Substantive response of the Local Highway Authority to a planning consultation received under The Development Management Order.

Planning Application Number: 25/00201/FUL

Application Address: 11 Danehill, Ratby, Leicester, Leicestershire, LE6 0NG.

Description of Application: Re-consultation. Erection of one dwelling

Figure 1 – Parallel parking formation.

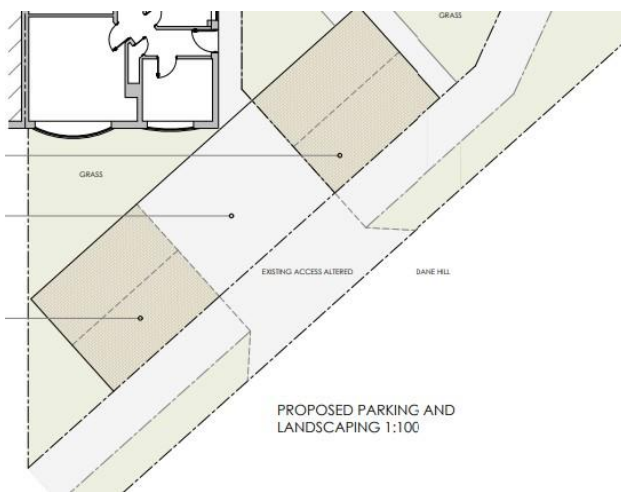
The Applicant previously proposed two off-street parking spaces per dwelling, parallel to the public highway as per figure 1 below.

Figure 2 – Amended parking proposals.

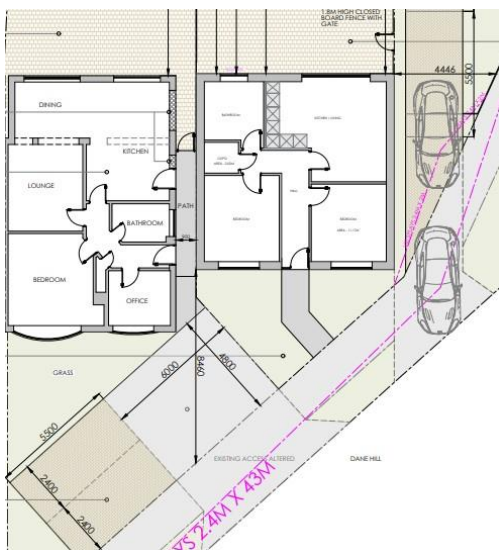
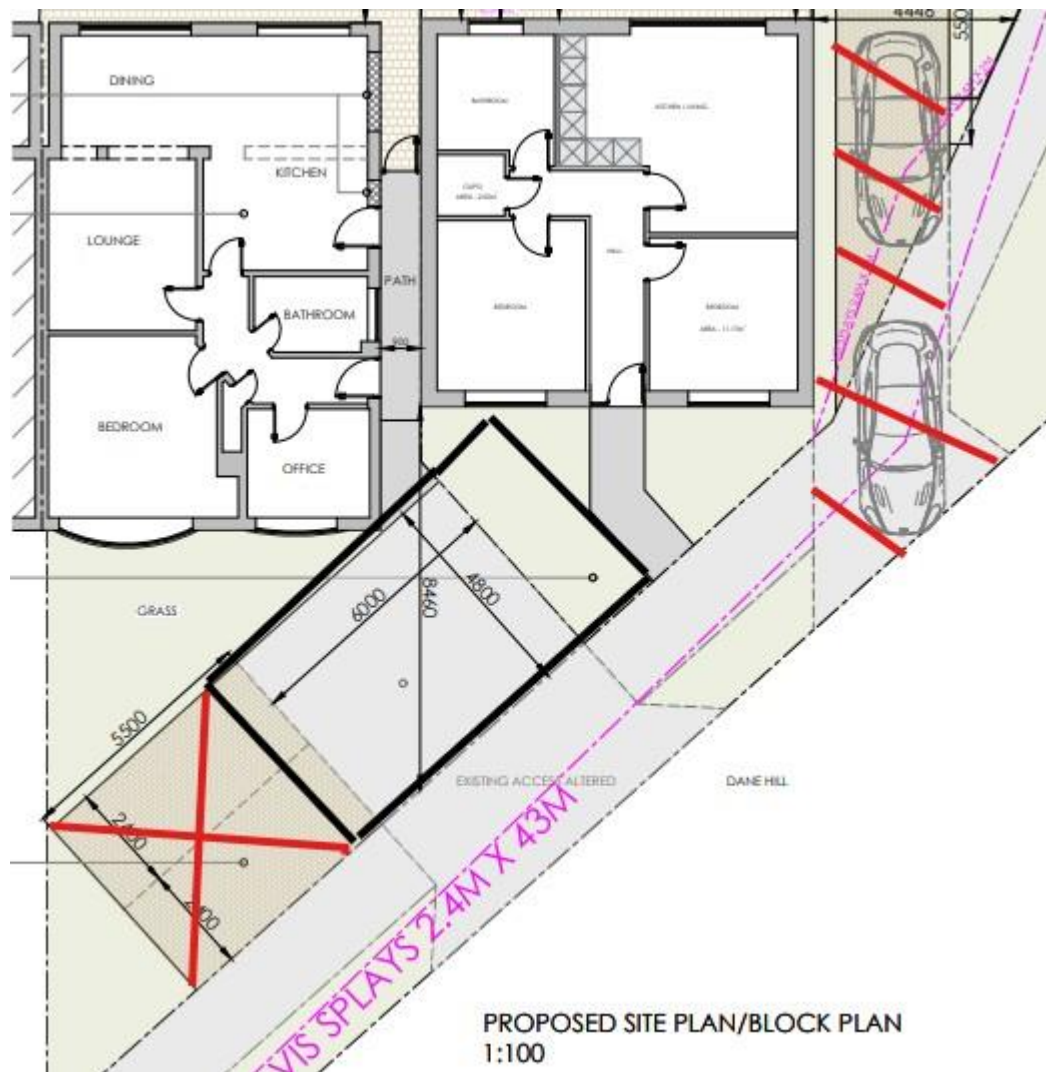
The proposed dwelling was previously to be set back within the site, the revised internal layout now demonstrates the rear elevations of both dwelling in-line, this then had implications for the previously proposed parking layout. The revised layout drawing titled 'Proposed Site Plan and Floor Plan', drawing number 24-63.02 demonstrates two off-street parking spaces parallel to the highway for the host dwelling and two off-street parking spaces perpendicular to the highway in a tandem formation as per Figure 2 below:

The LHA would request that the Applicant reconsiders the proposed off-street parking arrangements based upon the following.

In relation to the proposed dwelling, it would not be unreasonable to expect vehicles to reverse onto the public highway, this again could pose an issue for pedestrians approaching from the southwest, with their view possibility being obscured by the proposed dwelling.

The Applicant would also be expected to provide a detailed scaled vehicular visibility splay drawing demonstrating visibility splay lengths in accordance with [Table 6](#) of the LHDG, and should be based on 85th percentile vehicle speeds. These should be drawn in accordance with [Figure 7](#) of the LHDG and should be over the Applicant's or highway land, and not over third party owned land, to a point 1m into the highway.

Given the access would require widening to facilitate the off-street parking, the Applicant would be required to remove a section of grass verge. There may be statutory undertaker apparatus located within the verge/footway fronting the site; should an application be forthcoming and the LPA minded to grant the proposals, the Applicant would need to undertake surveys and potentially works to relocate any services if found. Any additional cost that arises because of this, would be entirely at the Applicant's expense.

The widened access would also be required to be surfaced with tarmacadam, concrete or similar hard bound material (not loose aggregate) for a distance of at least 5m behind the highway boundary. This could be secured via condition.

Table 28 of the LHDG states that for dwellings with up to three bedrooms two off-street parking spaces should be provided. Given this, the LHA would request that two off-street parking spaces be provided for the host dwelling as per the existing situation.

In relation to the proposed dwelling, it is noted it is within easy reach of Main Street with all the amenities it has to offer, and bus stops providing services to neighbour settlements and the city of Leicester. As such, in these site-specific circumstances the LHA would accept one off-street parking space.

It is noted that the proposed spaces would be 4.8m in length. Having reviewed the drawing titled 'Existing Site / Ground Floor Plans & Section / Elevations', drawing number 24-63.01 Rev A this would be in accordance with the extant situation. As such, in this would be acceptable in these site-specific circumstances.
